**LICENSE AMENDMENT REQUEST**  
**STRETCH POWER UPRATE**

**MARK-UP OF THE OPERATING LICENSE AND TECHNICAL**  
**SPECIFICATIONS PAGES**

**DOMINION NUCLEAR CONNECTICUT, INC.**  
**MILLSTONE POWER STATION UNIT 3**

FIGURE 3.4-5

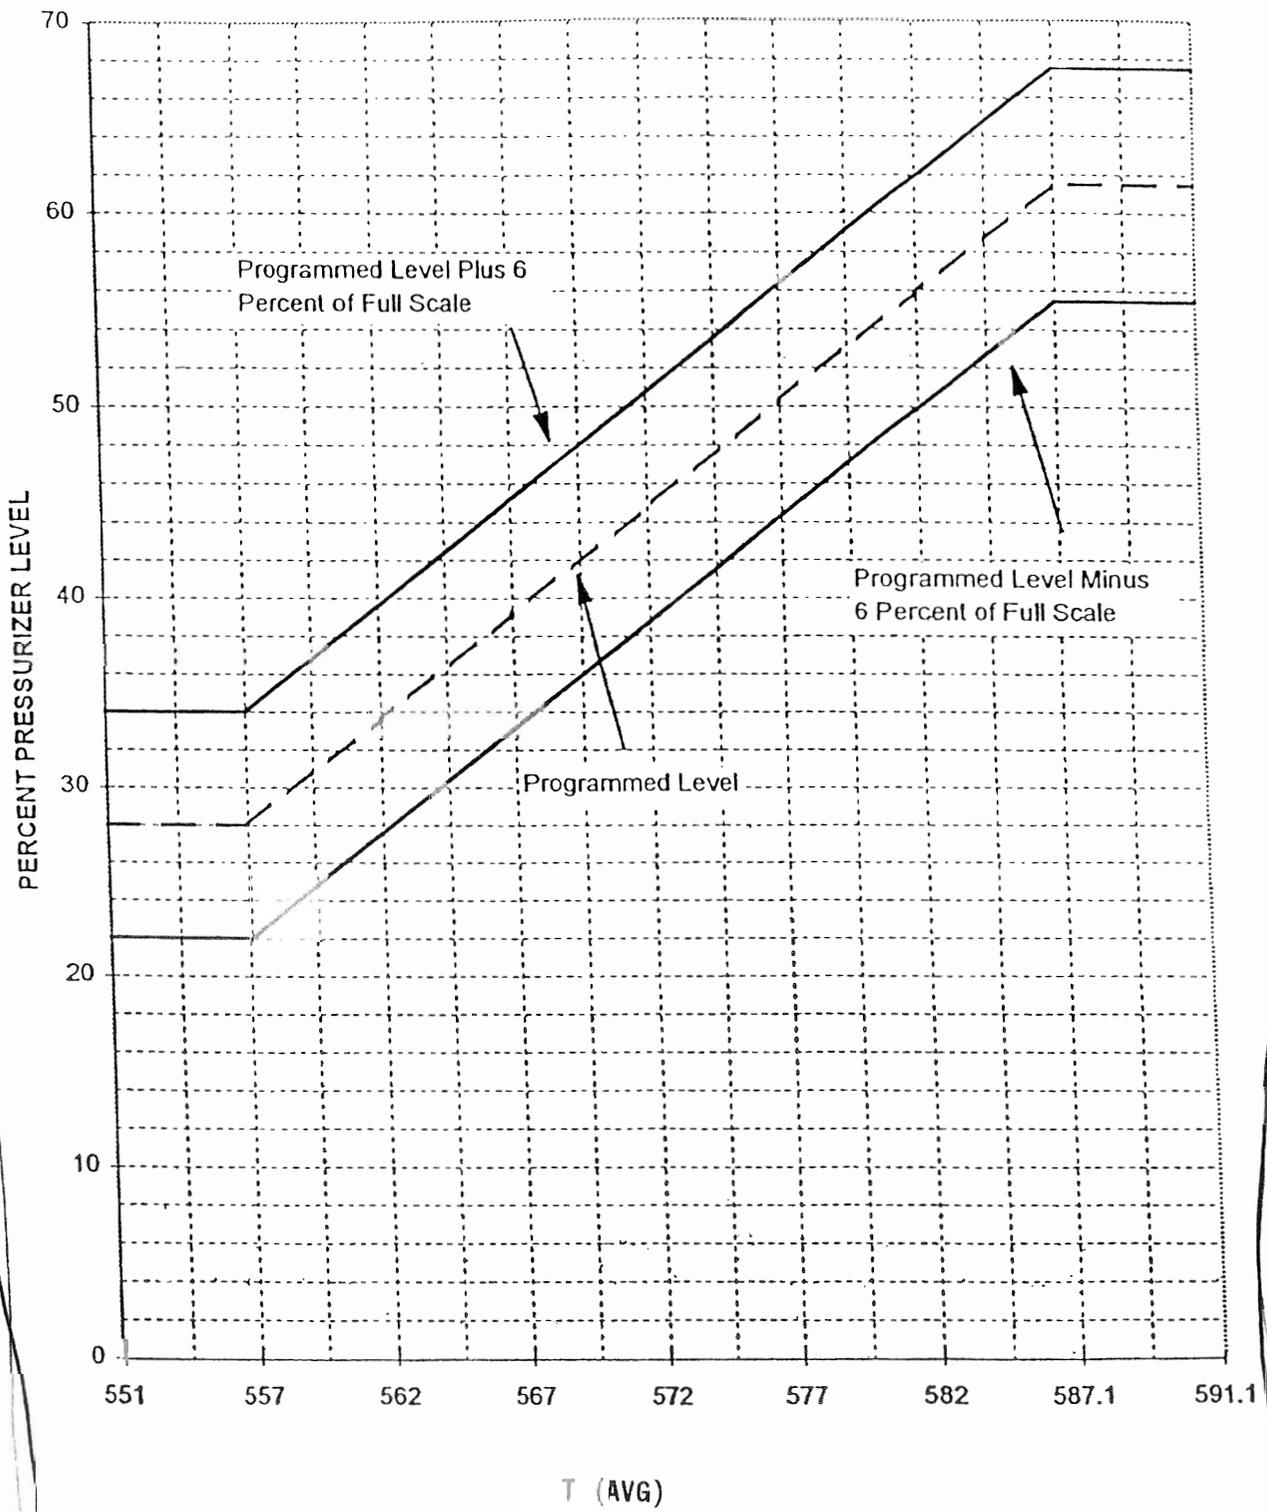
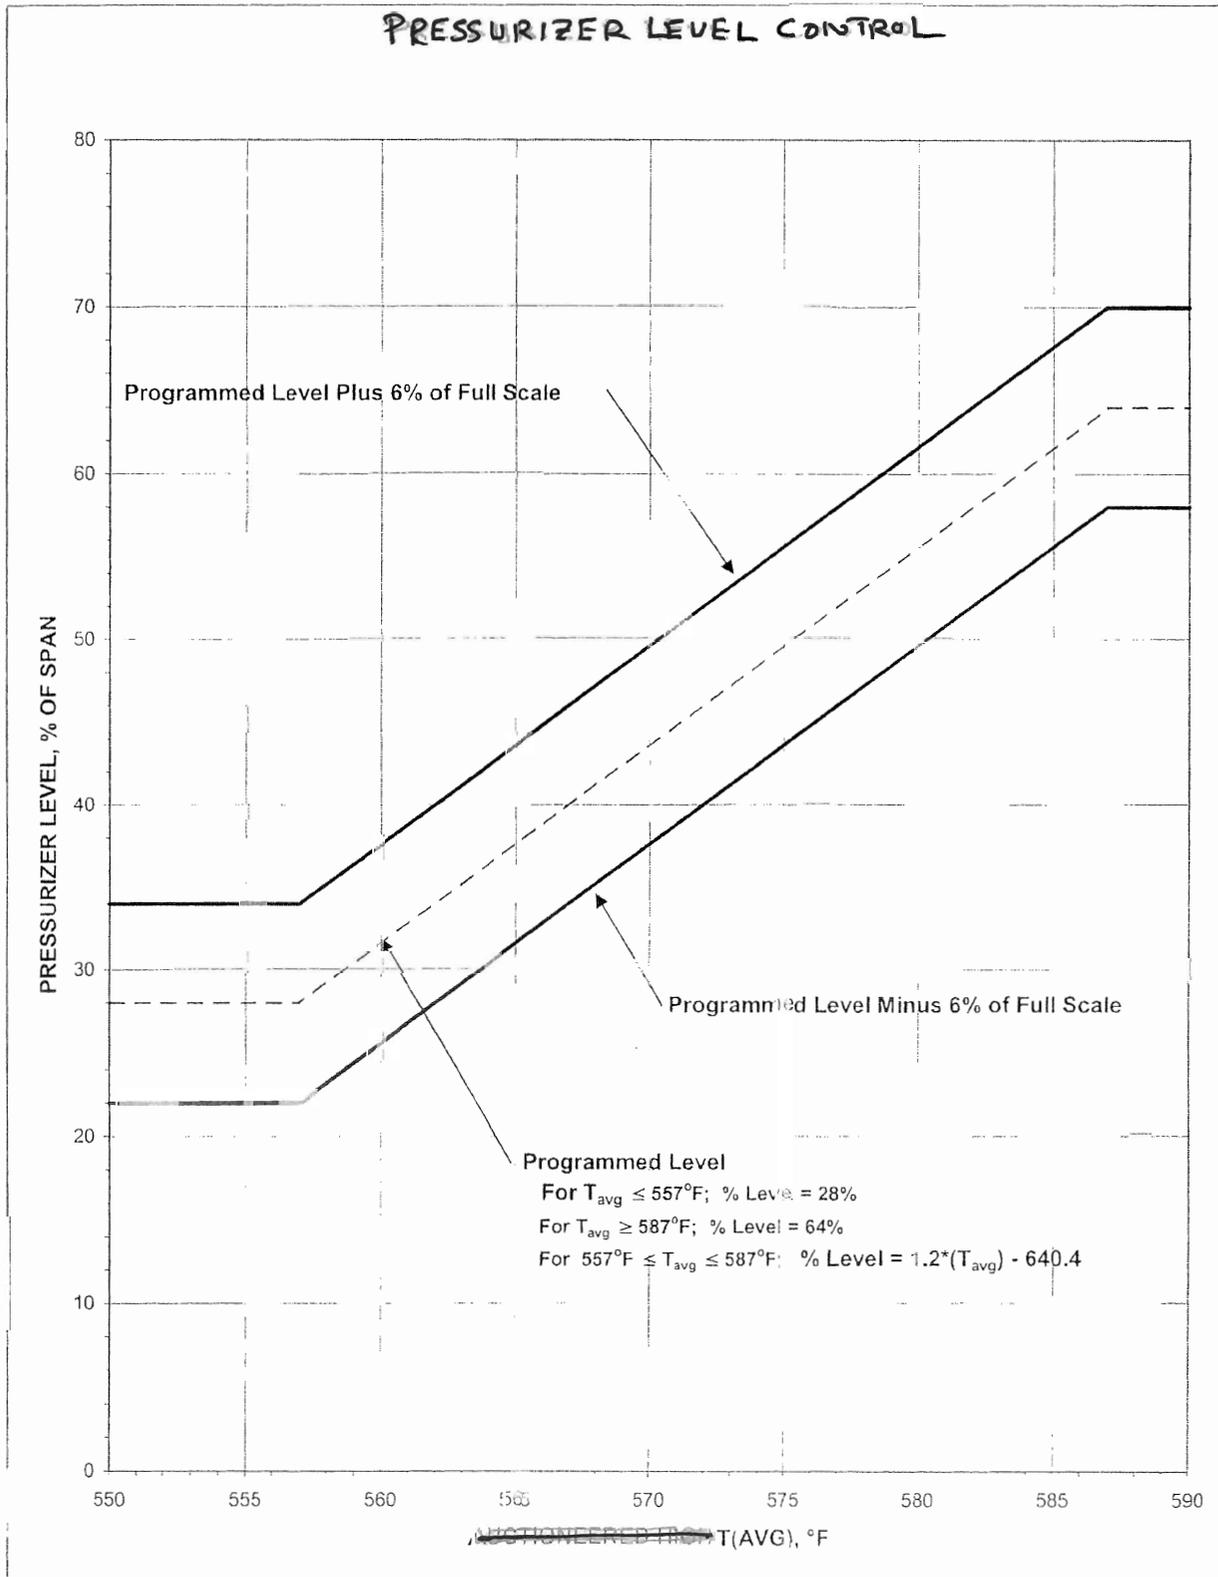
Replace with the NEW FIGURE NEXT PAGE

FIGURE 3.9-3 Minimum Fuel Assembly Burnup Versus Nominal Initial Enrichment for Region 2 Storage Configuration

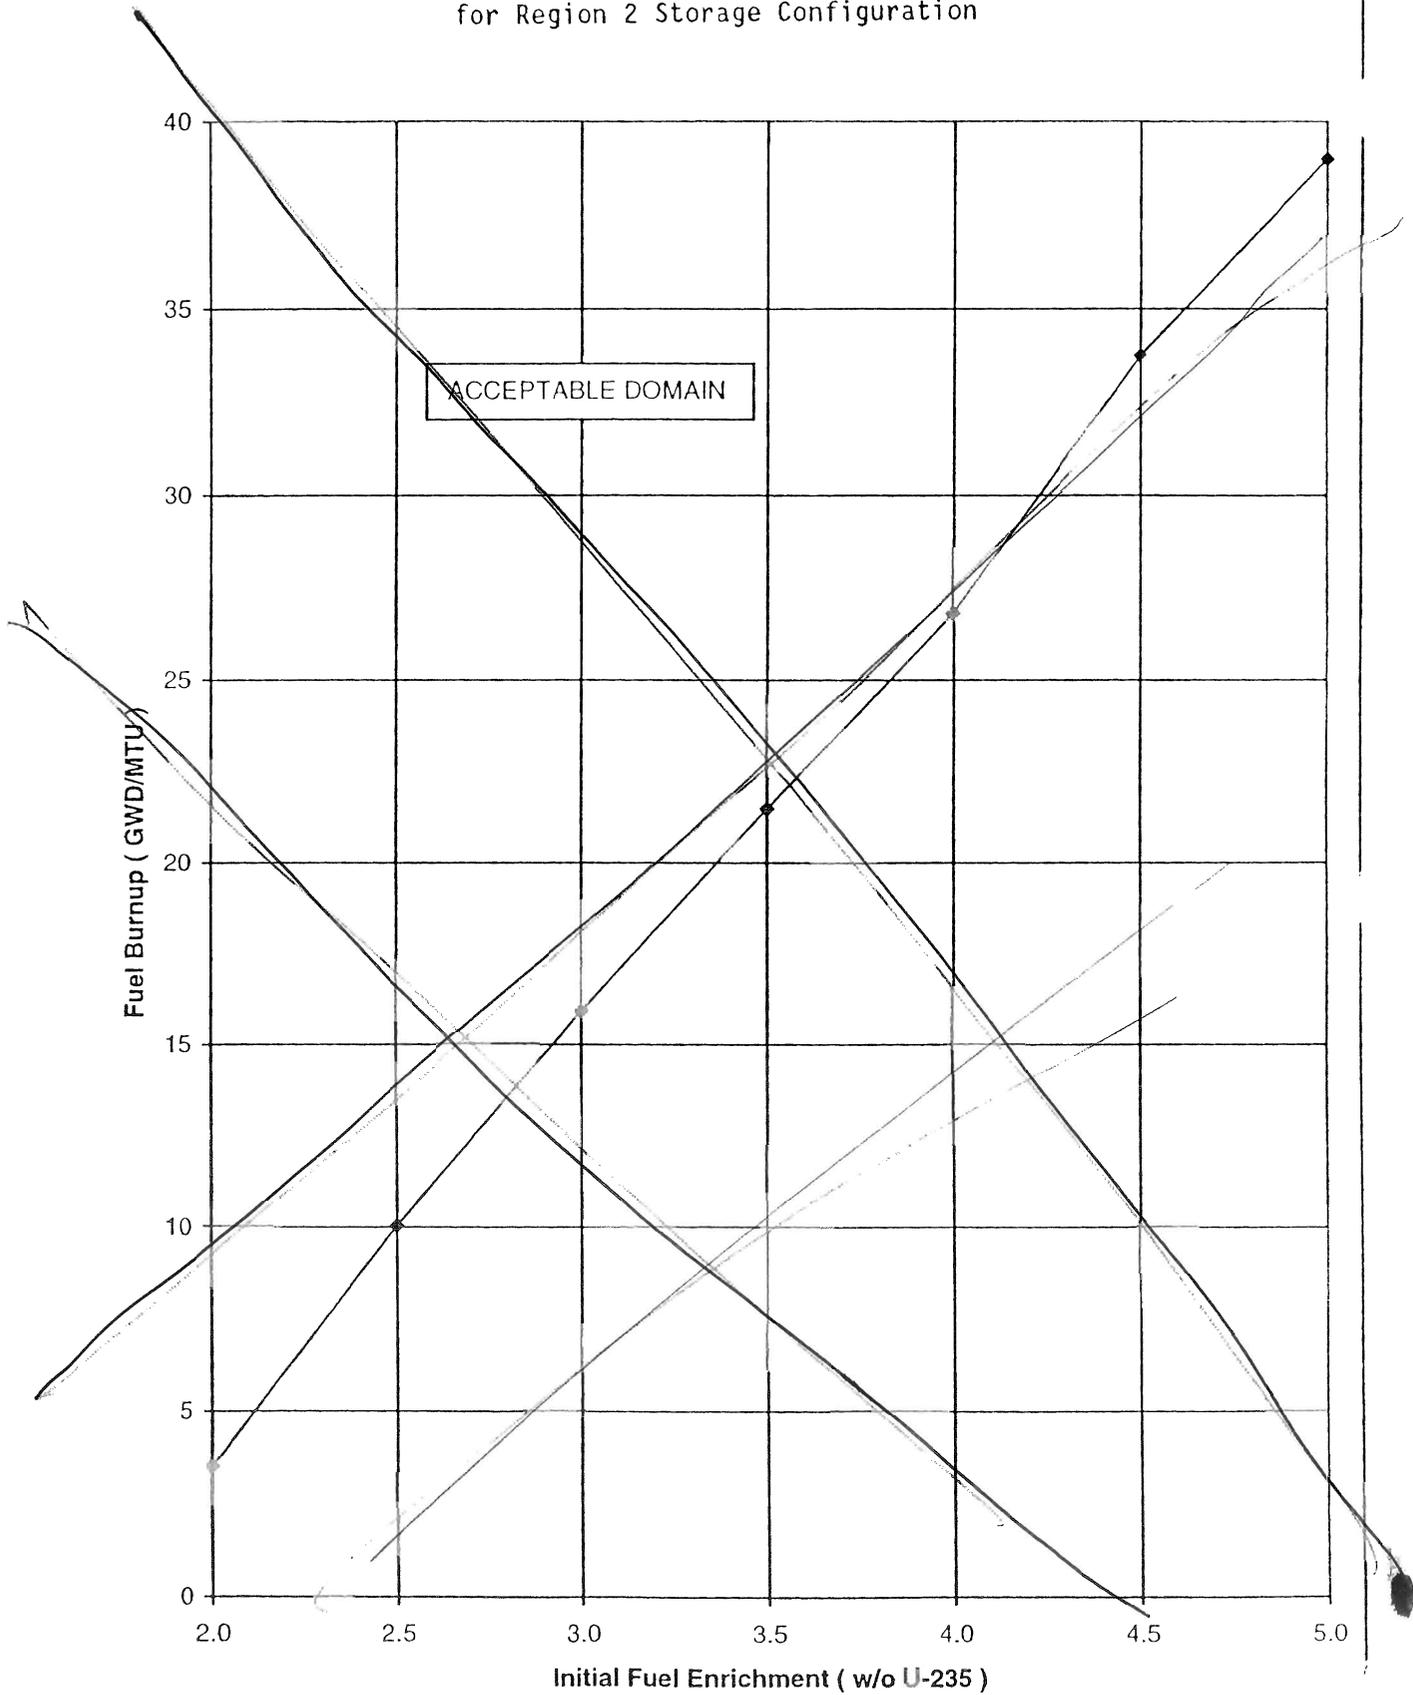
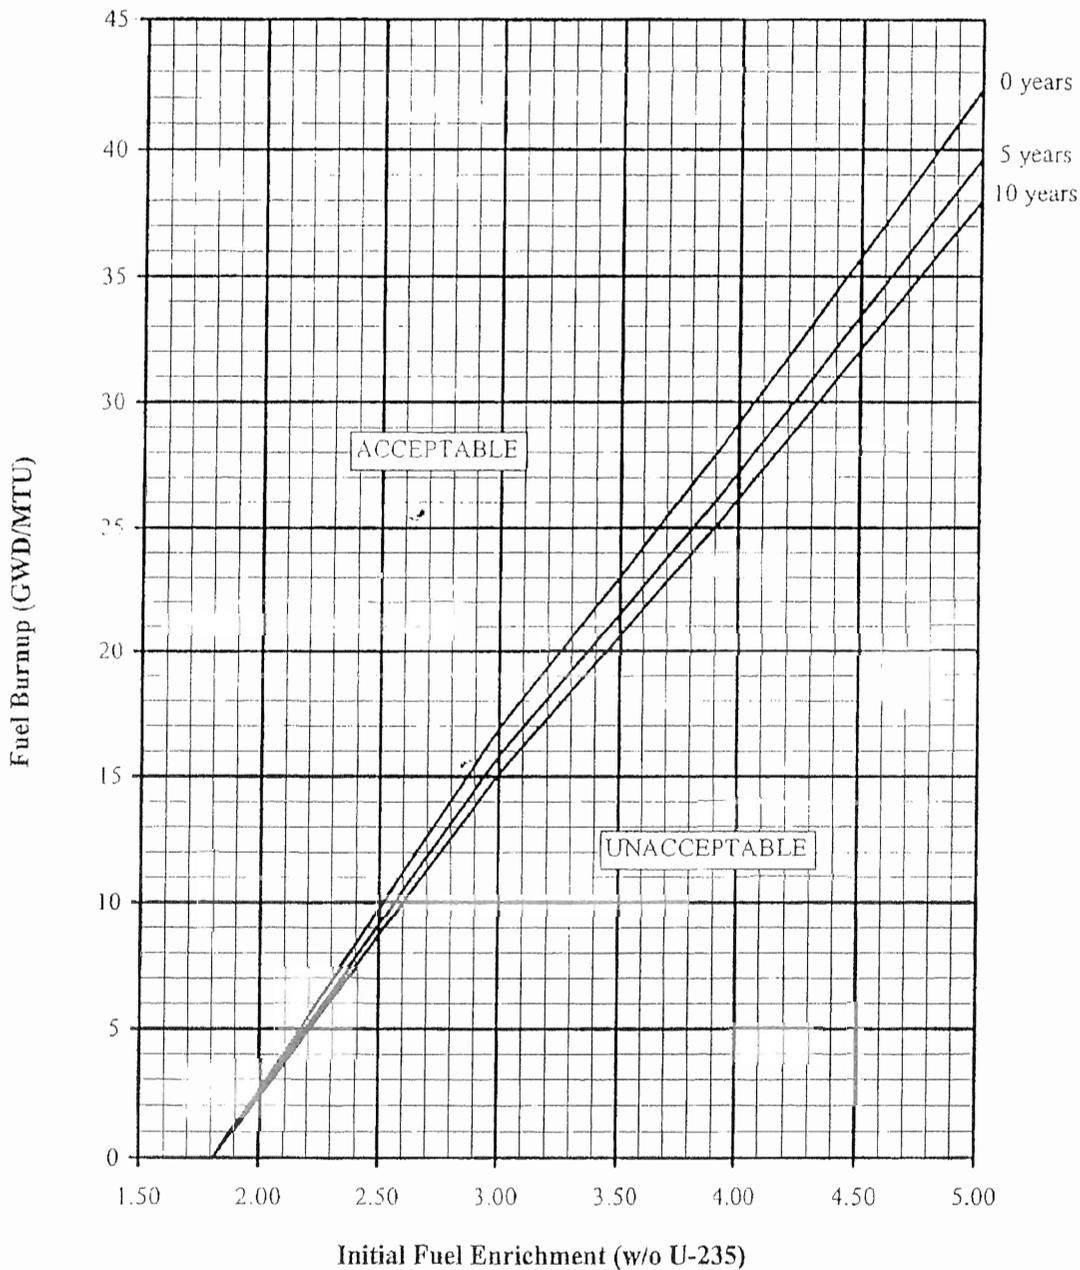
REPLACE WITH NEXT PAGE

Minimum Fuel Assembly Burnup and Decay time Versus Nominal Initial Enrichment for Region 2 Storage Configuration

FIGURE 3.9-4 Minimum Fuel Assembly Burnup and Decay Time Versus Nominal Initial Enrichment for Region 3 Storage Configuration **For Assemblies from Pre-Upgrade (3411 MWt) Cores**

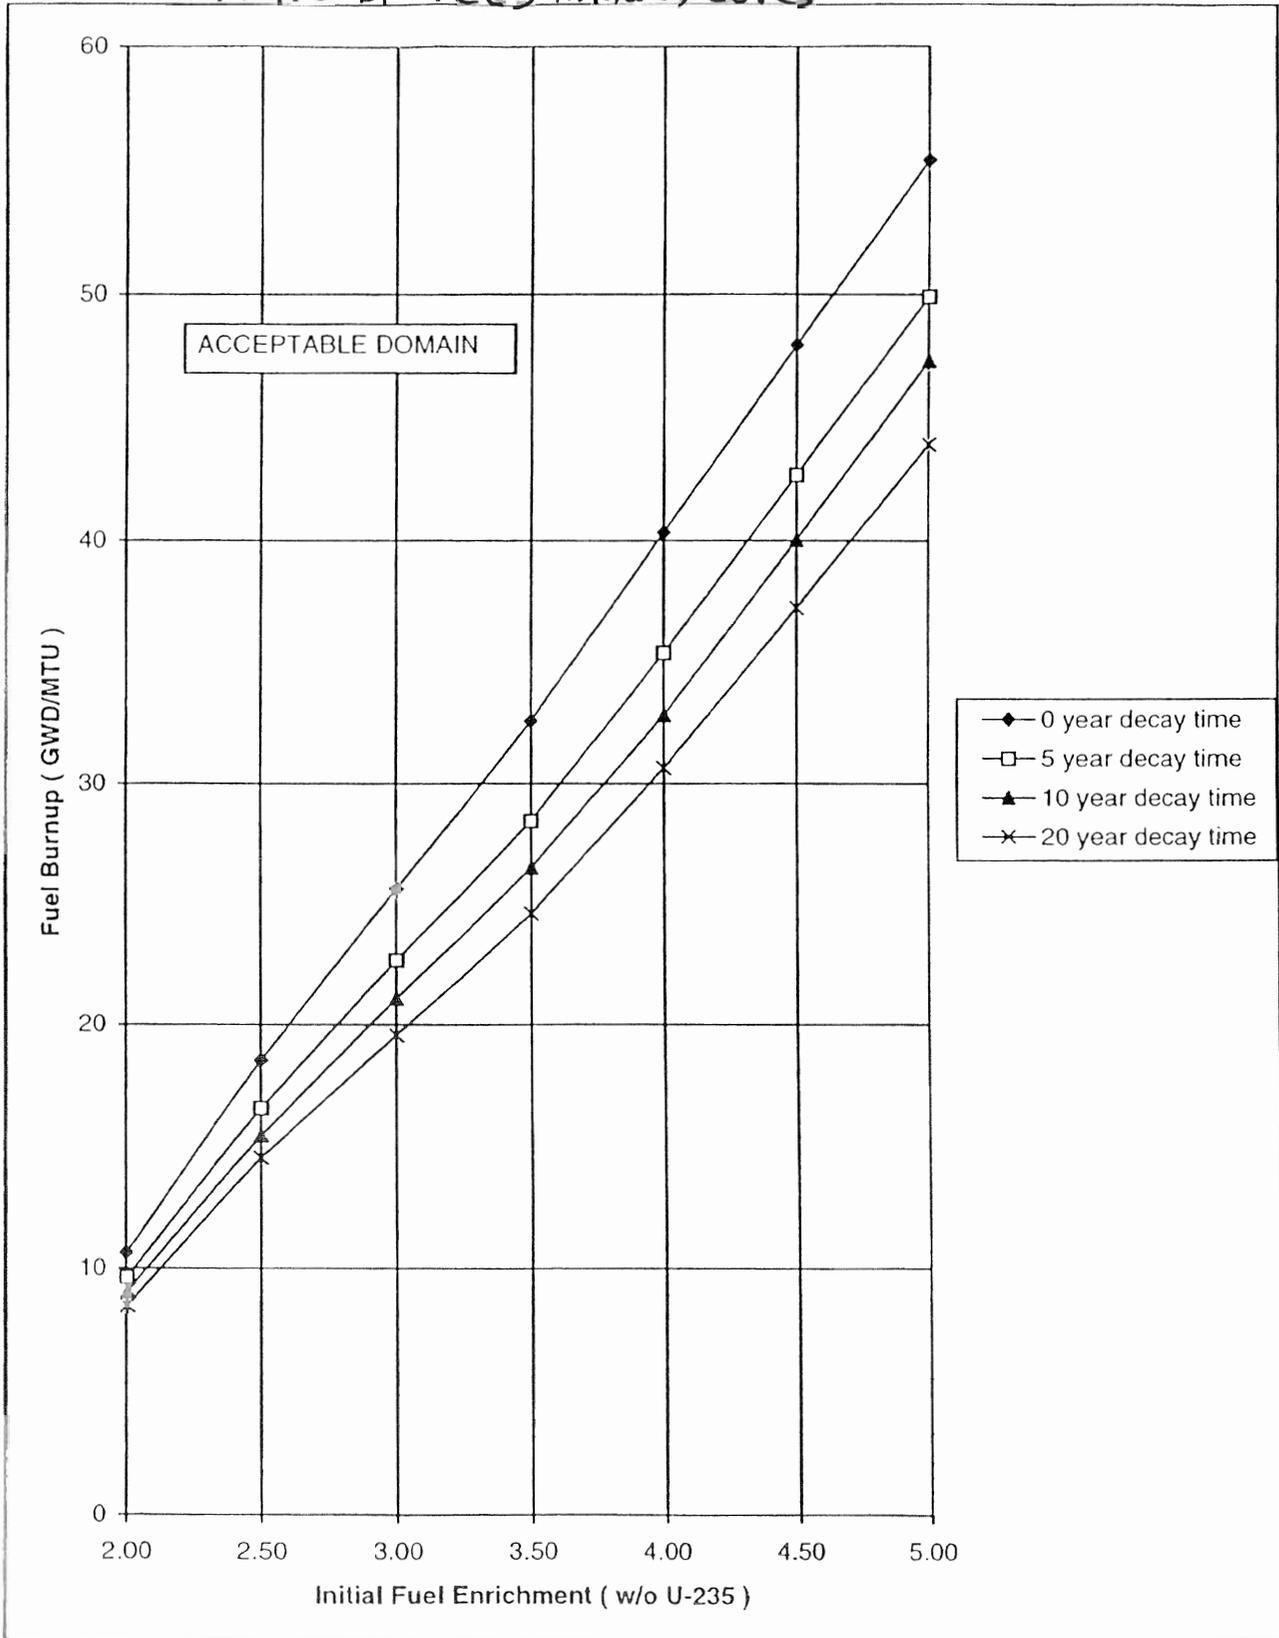
4.9.13.1.3. Ensure that all fuel assemblies to be placed in Region 3 fuel storage are within the enrichment, decay time, and burnup limits of Figure 3.9-4 by checking the fuel assembly's design, decay time, and burn-up documentation. *used exclusively in pre-uprate (3411 must) conditions which are*

FIGURE 3.9- Minimum Fuel Assembly Burnup and Decay Time Versus Nominal Initial Enrichment for Region 3 Storage Configuration  
*for Assemblies from Post-Update (36.50Mwt) Cores*

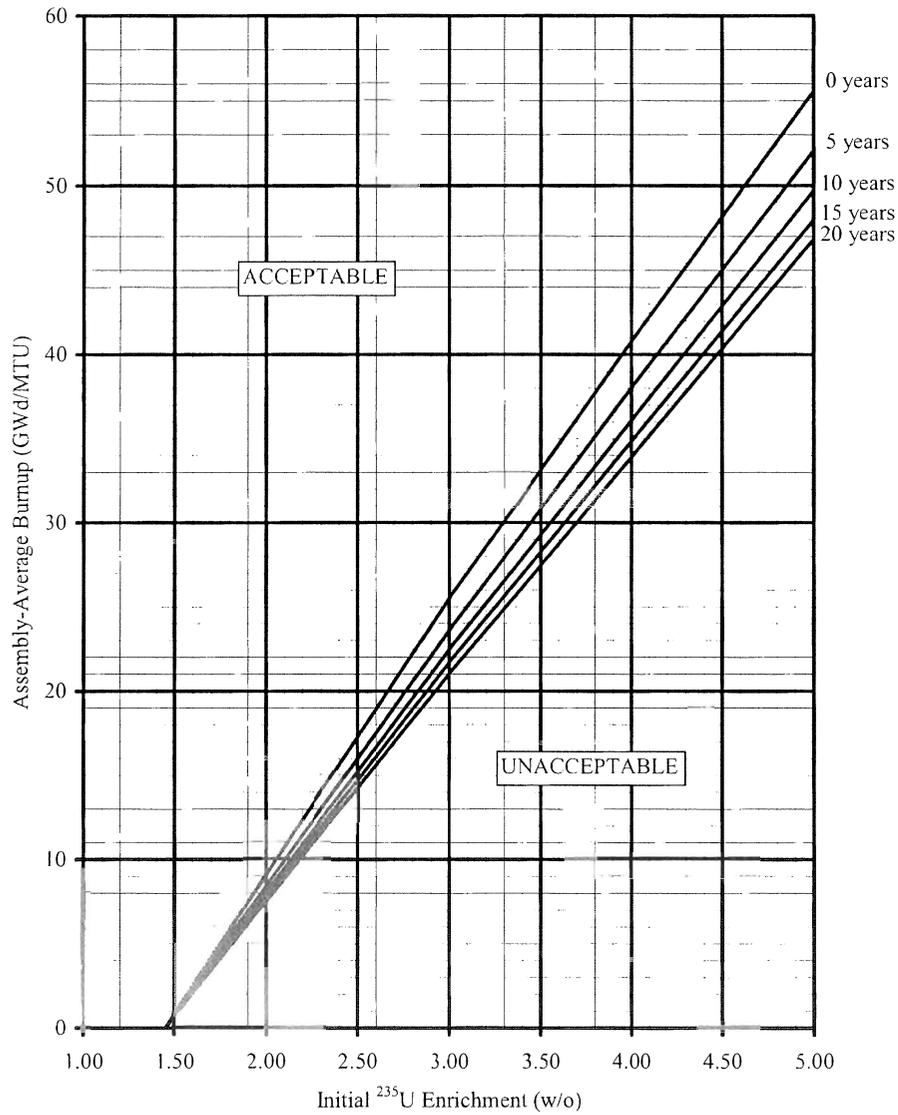
*Ensure that all Fuel assemblies used in post-uprate (.3650 MWT) conditions which ~~are~~ are to be placed in Region 3 Fuel storage are within the enrichment, decay time, and burn-up limits of Figure 3.9-5 by checking the fuel assembly's design, decay time, and burn-up documentation.*
